## IDAP REPORT

<b>Property:</b>	51-55 Homebush Road STRATHFIELD Lot 2 in DP1886 & Lot 11A in DP 17492 DA2021.211
<b>Proposal:</b>	Alterations and additions to an existing boarding house (LEC approved) and heritage item - I147 ("Merriwa"—Federation house), including provision of ramp.
<b>Applicant:</b>	C & C Investment Pty Ltd
<b>Owner:</b>	C & C Investment Pty Ltd
<b>Date of lodgement:</b>	25 August 2021
<b>Notification period:</b>	30 August 2021 – 20 September 2021
<b>Submissions received:</b>	One (1) written submission received
<b>Assessment officer:</b>	L Gibson
<b>Estimated cost of works:</b>	\$10,000.00
<b>Zoning:</b>	R2-Low Density Residential - SLEP 2012
<b>Heritage:</b>	Yes – Heritage Item I147 – “Merriwa” – Federation house under Schedule 5 of the SLEP 2012.
<b>Flood affected:</b>	No
<b>Is a Clause 4.6 Variation Proposed:</b>	No
<b>RECOMMENDATION OF OFFICER:</b>	<b>REFUSAL</b>

Figure 2: Approved Ground Floor Plan

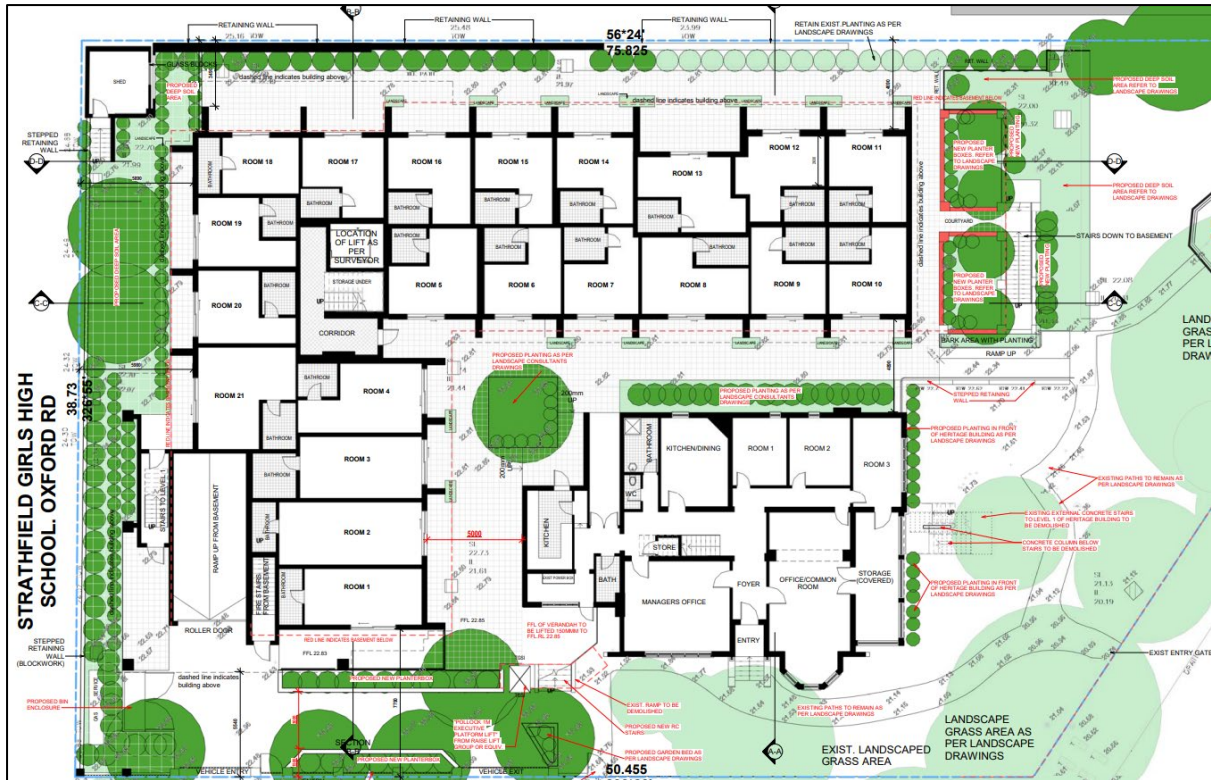
A comparison of the LEC approved development and the proposal is illustrated in Figures 2 to 5.
